South Holland
Drainage Board

Our Ref: 19_02068_C

Notice of Intention to Grant Consent to discharge surface water run-off into watercourse: Long Hope Farm, Frostley Gate, Holbeach Fen, Spalding, Lincolnshire PE12 8SR

Figure 1. Overall site plan, surface water network shown in green (extract taken from drawing 001-JCE-00-SI-DR-C-3000 P02, Jackson Consulting Engineers, 01/03/2020)

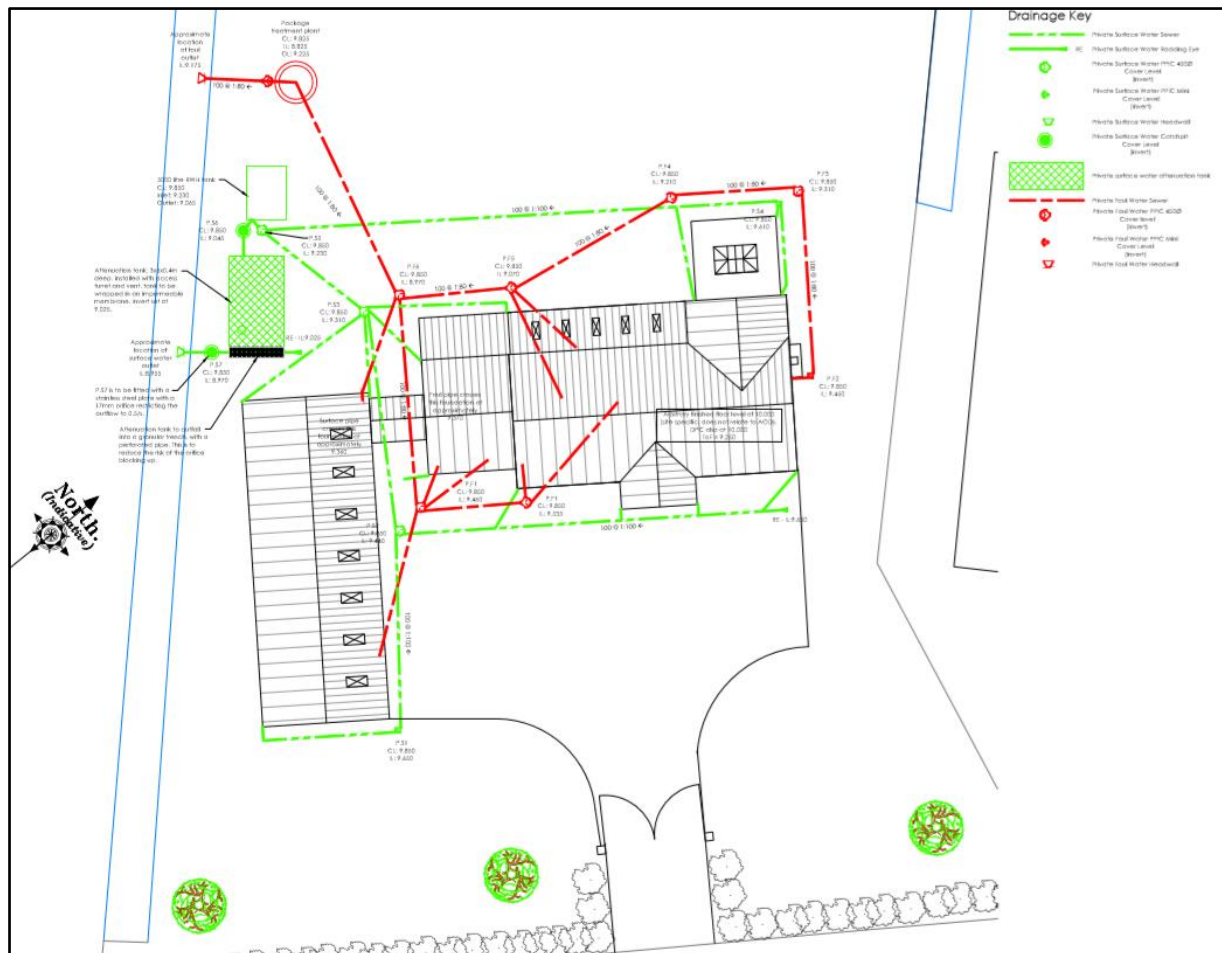
- C4 No impermeable surfaces which drain to a watercourse (whether directly or indirectly), other than the 349 m² (0.0349 hectares) approved as part of your current application, are to be constructed on site unless prior written consent is obtained from the Board.

Figure 2. Detail of surface water attenuation tank and outfall into private watercourse (extract taken from drawing 001-JCE-00-SI-DR-C-3000 P02, Jackson Consulting Engineers, 01/03/2020)

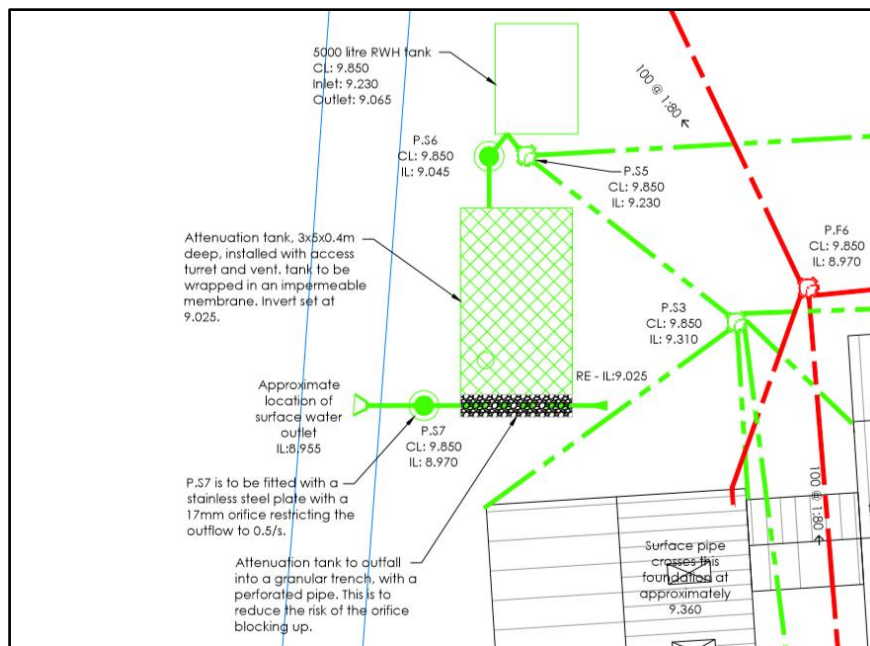
- S1.2 Outfall details: Consent is for the installation of a 100 mm diameter attenuation tank outfall pipe fitted with a 17mm stainless steel orifice plate (plus associated headwall) to be constructed in the private riparian watercourse located to the south-west of the site and at the approximate location 536523, 320953. The discharge of surface water run-off from this site is to be limited to a maximum rate of 0.5 litres per second under all circumstances. Any exceedance of the afore-mentioned maximum discharge rate may lead to further action being taken by the Board.

- S2.1 Headwall: Where constructing a new outfall this should enter the watercourse through a suitably-sized pre-cast concrete recessed headwall unit. The headwall and pipe should be installed so that no part protrudes beyond the existing bank profile at any point.

- S3 Revetment: You should ensure that the outfall from this drainage system has suitable erosion protection below the discharge pipe, across the drain bed and up the far bank (to the same level as the discharge pipe), for at least one metre either side of the headwall to prevent any scouring of the bank of the watercourse. All erosion protection must be dug into the bank so that no item protrudes beyond the existing batter profile at any point. All material which is excavated as part of the headwall installation is to be removed from the watercourse, with the area around the new headwall and erosion protection restored to its previous condition as soon as possible.
